SUBJECT: IFB #PW23-1, Library Flat Roof Replacement, Project XPL277

Addendum #2

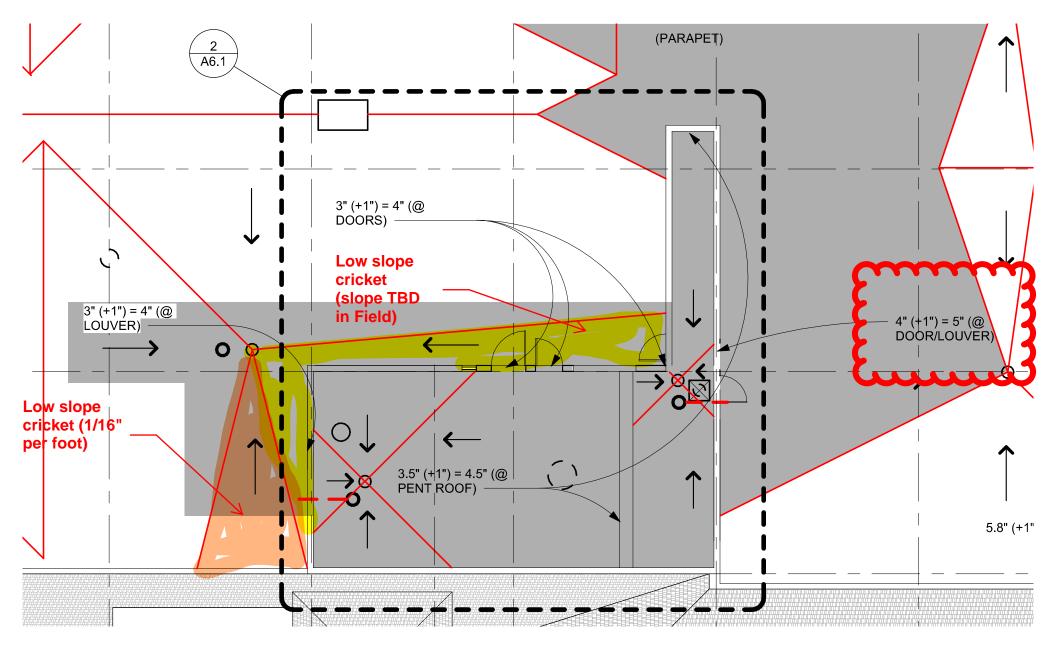
Q: Detail A6.5-11 and A6.5-9 locations are not shown on the roof plan, detail plans and elevations. A: These details are keyed on detail elevation 4/A6.2.
